APPEAL SUMMARY

Appeal ID: 20800	Project Address: 2167 NW Glisan St
Hearing Date: 8/28/19	Appellant Name: David Horsley
Case No.: B-010	Appellant Phone: (503) 388-3680
Appeal Type: Building	Plans Examiner/Inspector: Anne Schmidt
Project Type: commercial	Stories: 3 Occupancy: R-2 Primary, E secondary Construction Type: V-B
Building/Business Name:	Fire Sprinklers: Yes - NFPA 13R Throughout
Appeal Involves: Erection of a new structure	LUR or Permit Application No.: 19-172122-EA
Plan Submitted Option: pdf [File 1] [File 2]	Proposed use: Multifamily housing

APPEAL INFORMATION SHEET

1 WEST ELEVATION
SCALE : 1/16"=1'-0"

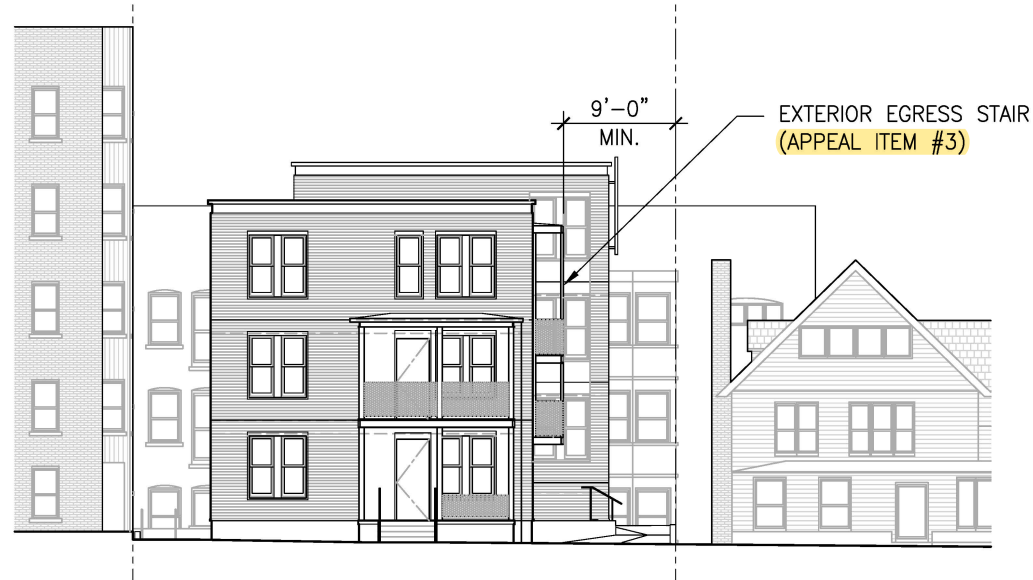
Requires	Exterior walls of the interior exit stairway and ramp shall comply with the requirements of Section 705 for exterior walls. Where nonrated walls or unprotected openings enclose the exterior of the stairway and the walls or openings are exposed by other parts of the building at an angle of less than 180 degrees, the building exterior walls within 10 feet horizontally of a nonrated wall or unprotected opening shall have a fire-resistance rating of not less than 1 hour. Openings within such exterior walls shall be protected by opening protectives having a fire protection rating of not less than 3/4 hour. This construction shall extend vertically from the ground to a point 10 feet above the topmost landing of the stairway or to the roof line, whichever is lower.
Proposed Design	<p>The proposed stair design is an exterior egress stairway in compliance with OSSC section 1026 (except where proposed in appeal item #3 below). It is enclosed on three sides by 2-hour rated walls, and open to an exterior garden court on the fourth side. The landings protrude +/- 3' from the face of the exterior walls. The exterior walls are 1-hour rated within 10 feet horizontally of the protruding landings as required. In lieu of a 3/4-hour rated window, the alternate design proposes a single unrated, non-operable window located within the 10 foot rated wall zone on either side of the stair. These windows will each be protected by a sprinkler located on the interior, occupied side of the window, a minimum of 6 inches and a maximum of 12 inches from the opening and a maximum of 12 inches below the ceiling, on the occupied side of the window.</p> <p>The stair itself will be equipped with side wall sprinklers and constructed with non-combustible components (steel structure and guardrails, concrete treads and landings).</p> <p>The windows proposed to be non-operable are in the living/dining area of the units, so the required emergency rescue openings in the sleeping rooms are still provided per the OSSC.</p>

Proposed Design The west wall of the south building is approximately 7 feet from the property line, therefore windows less than 10 feet from the property line are required to be ¾-hour rated and non-operable. The proposed alternate design provides ¾-hour rated windows, as required. Where required for OSSC emergency rescue openings, the design proposes operable windows which are protected by a dedicated sprinkler located on the interior, occupied side of the window, a minimum of 6 inches and a maximum of 12 inches from the opening and a maximum of 12 inches below the ceiling.

UNRATED, NON-OPERABLE
WINDOWS, SPRINKLER
PROTECTED ON THE INTERIOR
(APPEAL ITEM #1)

UNRATED, NON-OPERABLE
WINDOWS, SPRINKLER
PROTECTED ON THE INTERIOR
(APPEAL ITEM #1)

3/4-HOUR FIRE RATED
OPERABLE WINDOWS
(APPEAL ITEM #2)

3/4-HOUR FIRE RATED
NON-OPERABLE WINDOWS
(APPEAL ITEM #2)

1. Type 13 water curtain sprinkler protection at non-fire rated openings in exterior walls within 180 degrees of exit stair: Granted provided the 1st floor doors on the West elevation are minimum 45 minute rated.

2. Type 13 water curtain sprinkler protection at non-fire rated openings in exterior walls of egress court less than 10' in width: Granted provided the non-rated windows are non-operable, and sprinklers are spaced not more than 6 feet apart and placed a minimum of 6 inches and a maximum of 12 inches from the opening(s) and a maximum of 12 inches below the ceiling. Sprinklers are to be installed on the occupied side of the openings. A separate permit from the Fire Marshal's Office is required.

2 EAST ELEVATION
SCALE : 1/16"=1'-0"

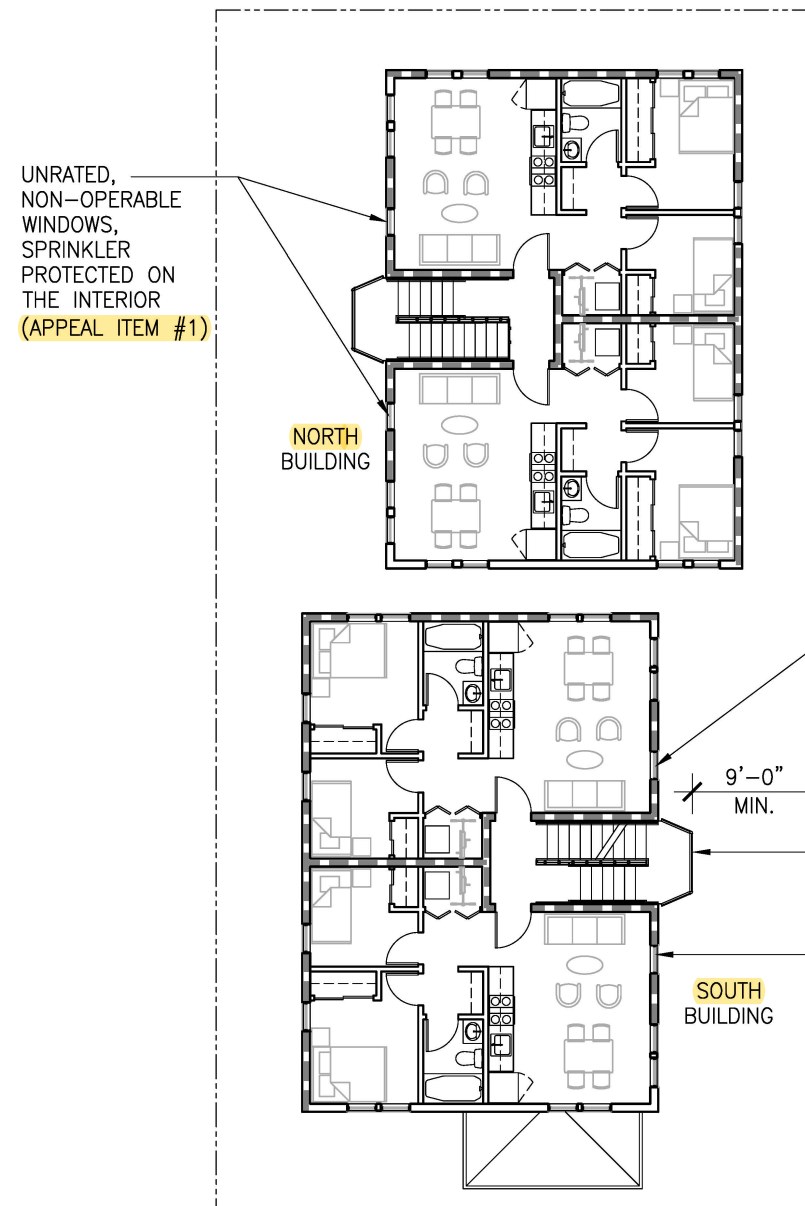
Code Section	OSSC 1026.5
Requires	Exterior exit stairways and ramps shall have a minimum fire separation distance of 10 feet (3048 mm) measured from the exterior edge of the stairway or ramp, including landings, to adjacent lot lines and from other buildings on the same lot unless the adjacent building exterior walls and openings are protected in accordance with Section 705 based on fire separation distance.
Proposed Design	We request a small, 1 foot reduction in the required fire separation distance for the exterior exit stairway at the south building (from 10 feet to 9 feet). As noted above, the stair is enclosed on three sides with a 2-hour fire rated wall, is protected with side-wall sprinklers, and is constructed of noncombustible components (steel structure and guardrails, concrete treads and landings). The stair width exceeds the minimum required for less than 50 occupants, even though the total occupant is less than 12.

EXTERIOR EGRESS STAIR
(APPEAL ITEM #3)

9'-0"
MIN.

UNRATED, NON-OPERABLE
WINDOWS, SPRINKLER
PROTECTED ON THE INTERIOR
(APPEAL ITEM #1)

3. Exterior exit stair with 1 foot reduction in minimum fire separation distance: Granted provided the landings are of minimum 1 hour fire rated construction.
